Aerial view of the published outlet + course of the proposed quarry water - Turbid Lane - to route down sandy lane to the Dean Brook stream

from Fiona Hartley 16 Jan 18

10.80 Hydrology/Drainage/Flood Risk Issues

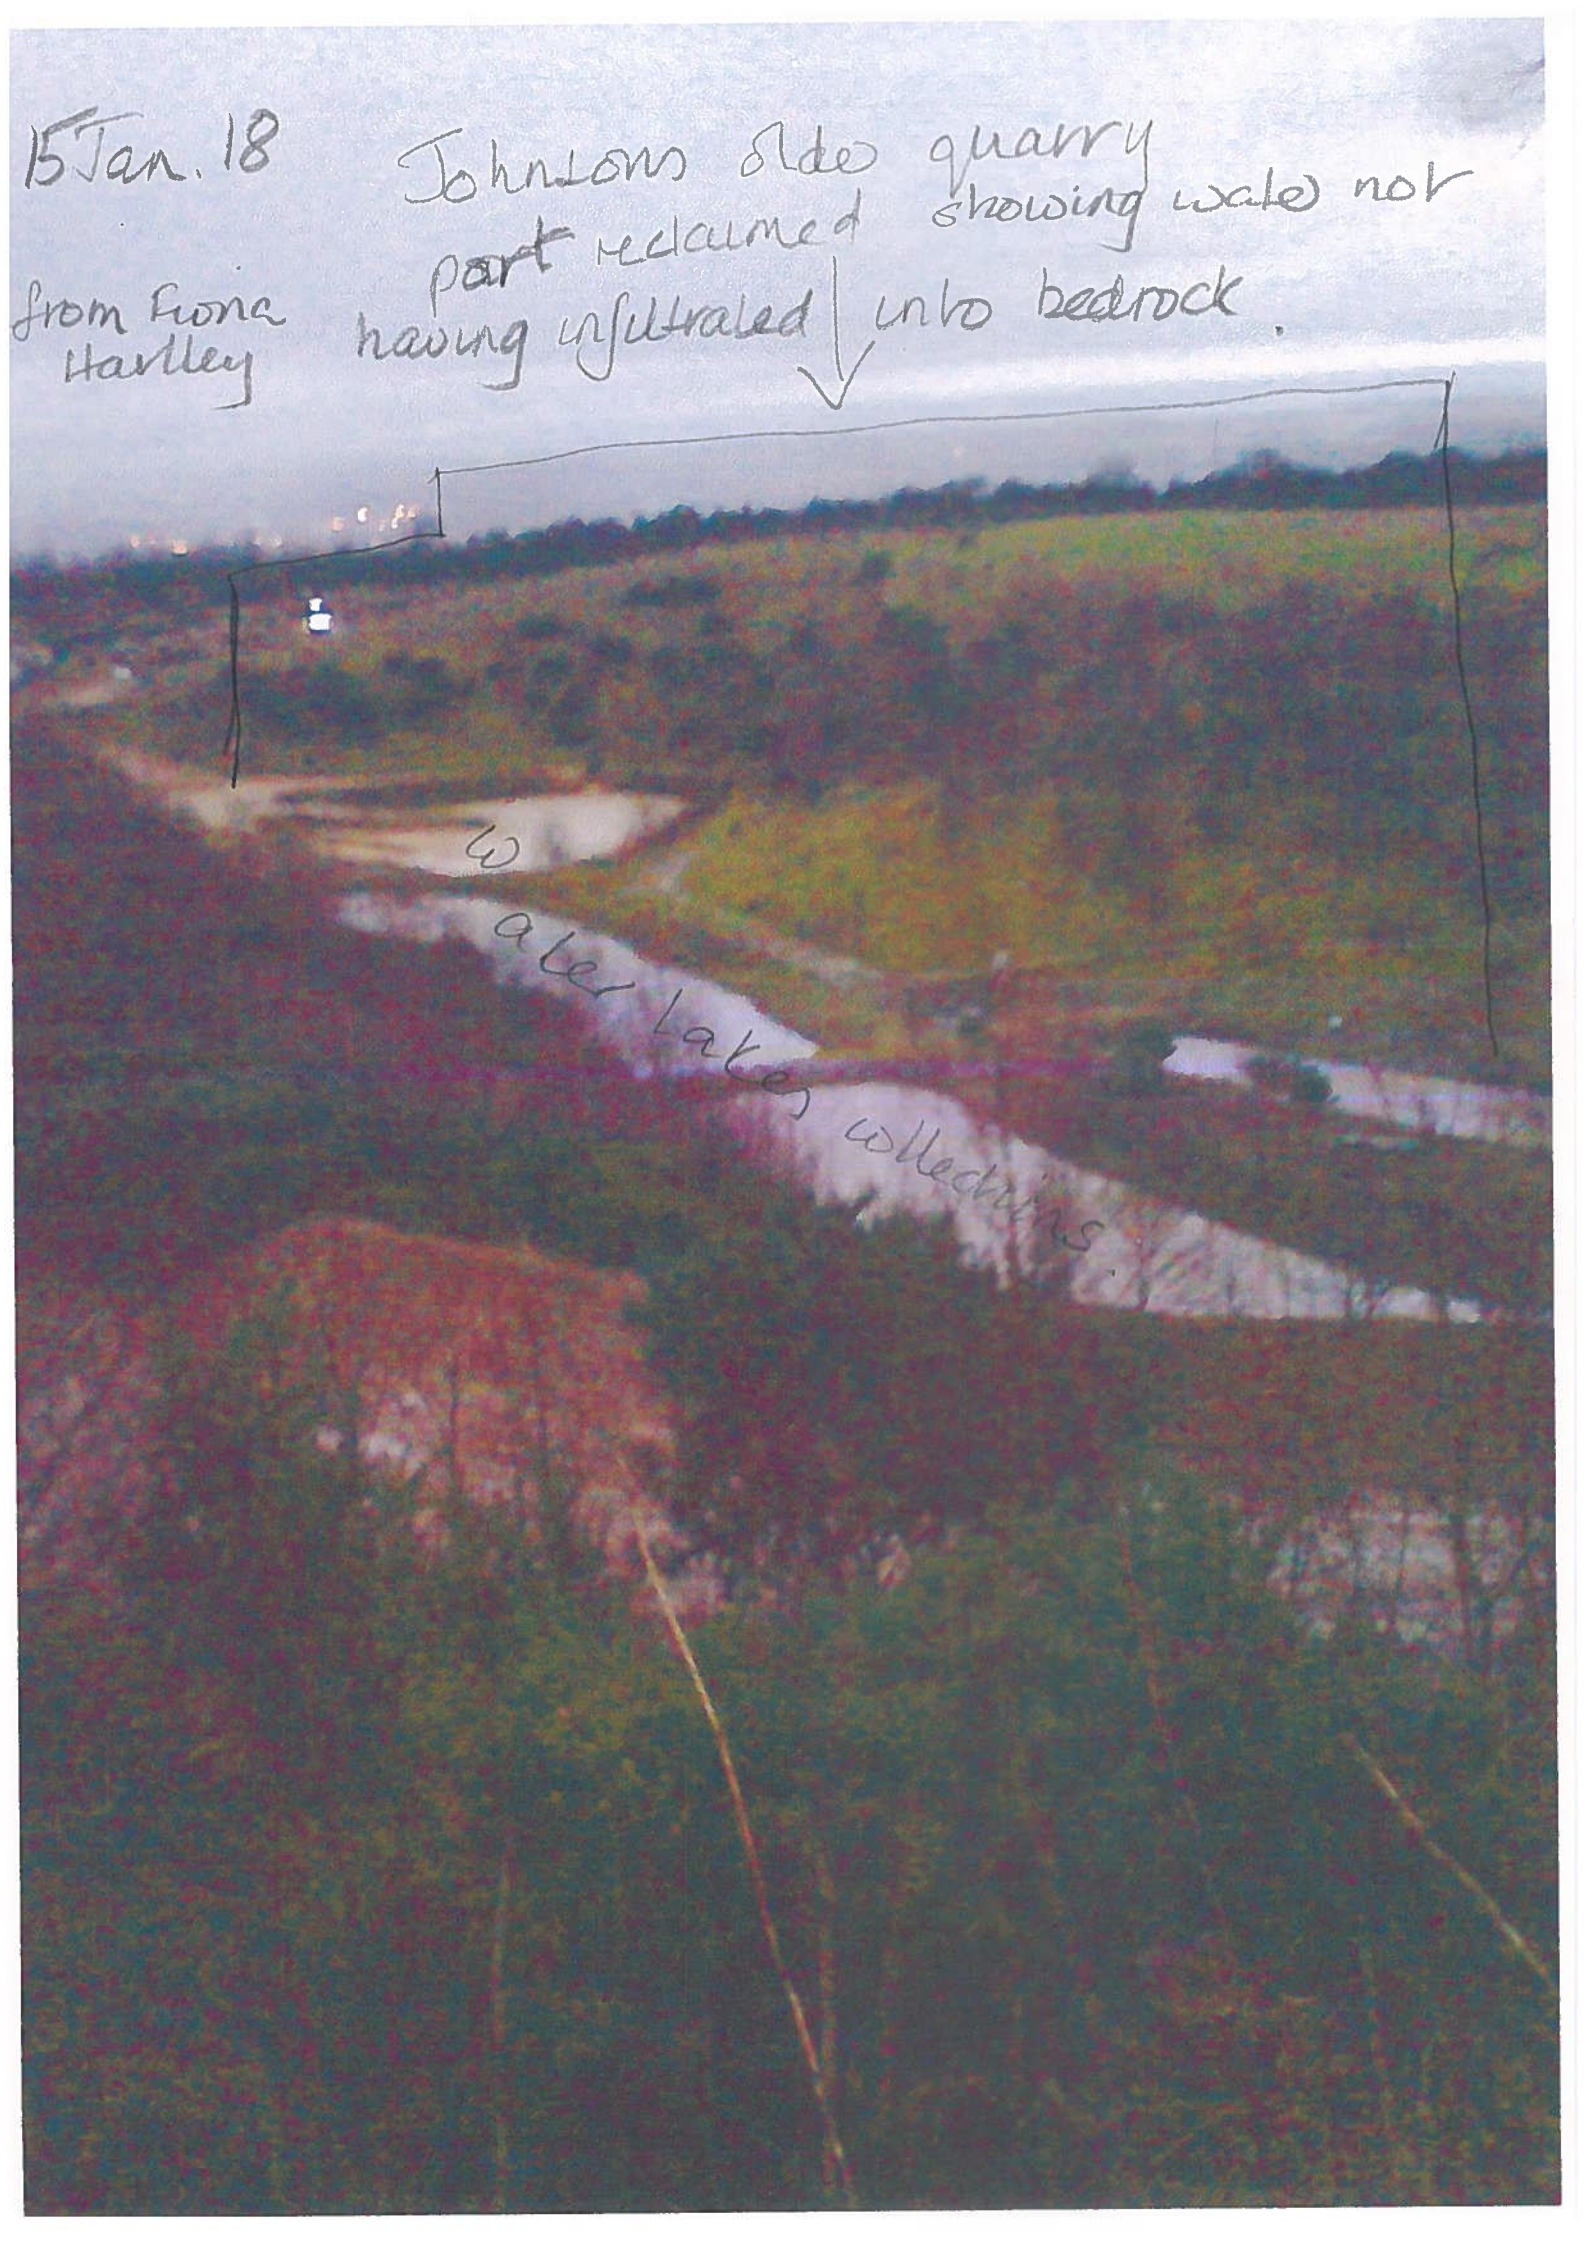
showing "lakes" - water collected in quarries
collected water has not been subject
"to a high perc. capacity to drain
infiltrating rain water"

Johnsons Olds quarry
part reclaimed showing water not
having infiltrated into bedrock.

Water Lakes collecting

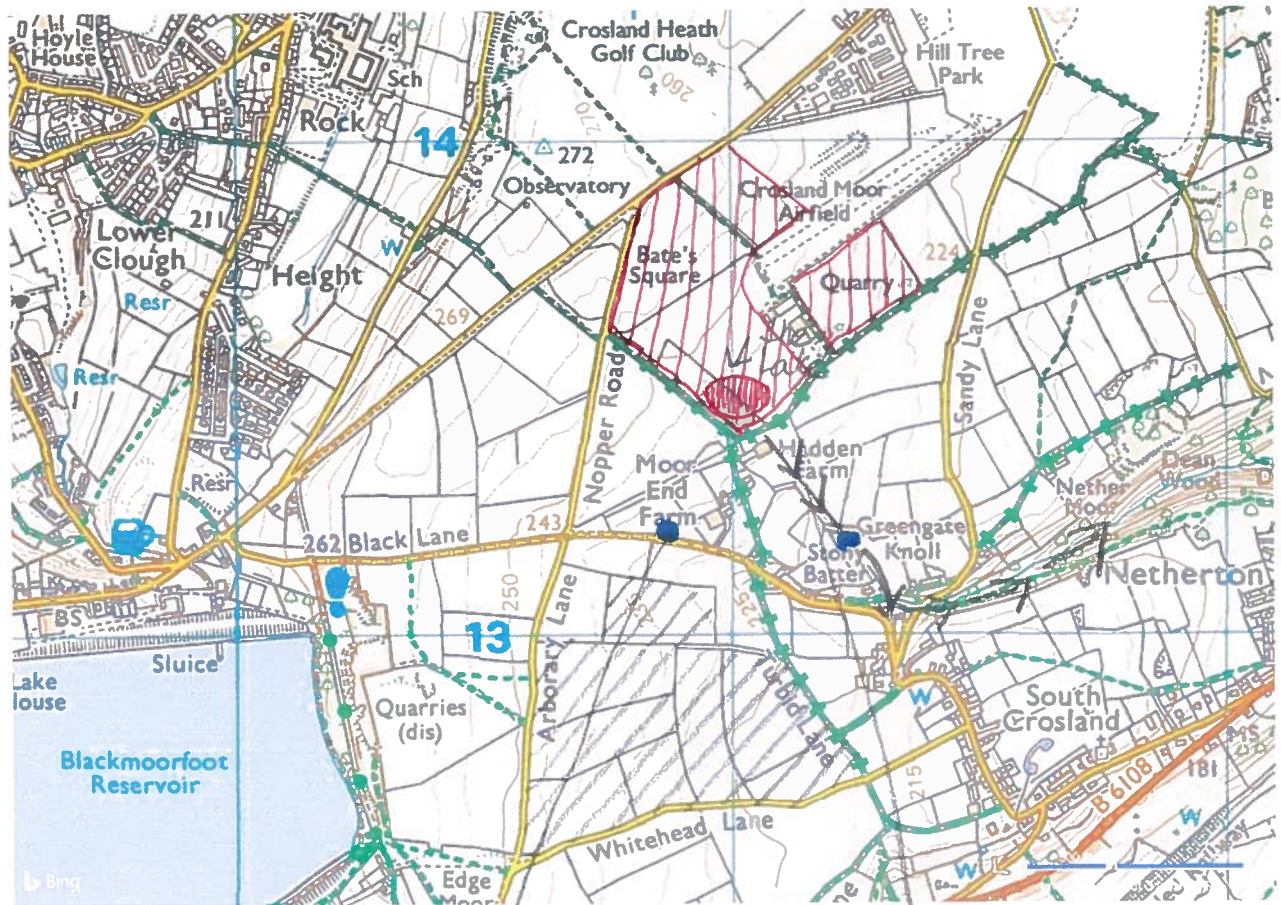
issue of direction of
 flow of the
 Rear Wood stream
 on 21 Jan 08 this
 higher part of the
 stream had a normal
 extension quarry
 flow

direction of
 flow of the
 deluge on 21 Jan 08
 from the airfield
 extension quarry

representation of the continuation of the ~~paper~~ map N from Dean Brook

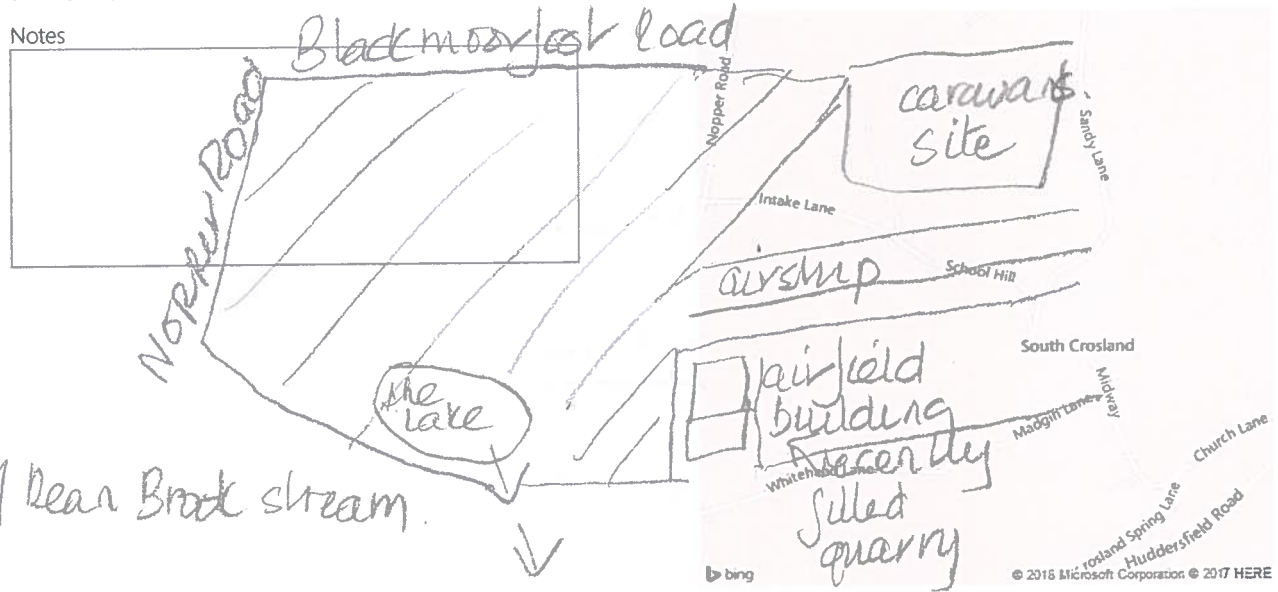
direction of the flow of deluge of 21 Jan 08

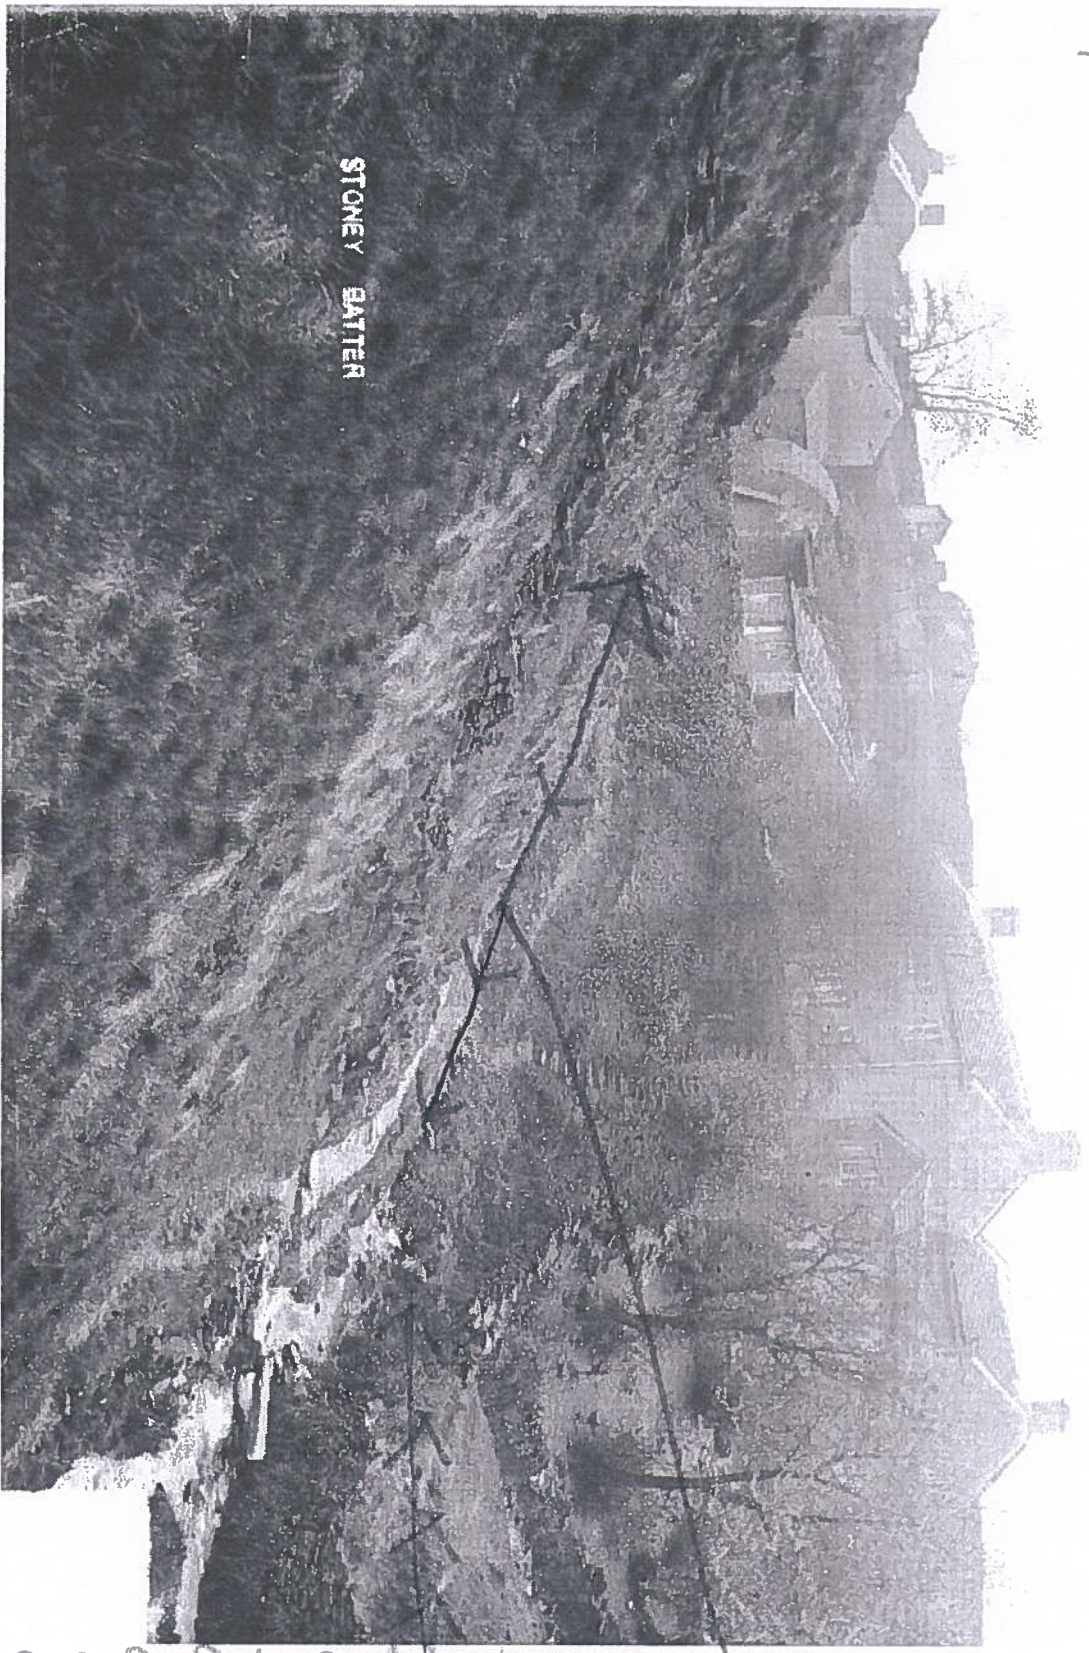
from the Francis Frith, c. 1910 approx. showing the Dean Brook valley public footpath across the "clapped bridge" which was shattered by the deluge of 1882 of gallons of water

direction of flow of Dean Brook

shown in bluey down which the odds of gallons of water came
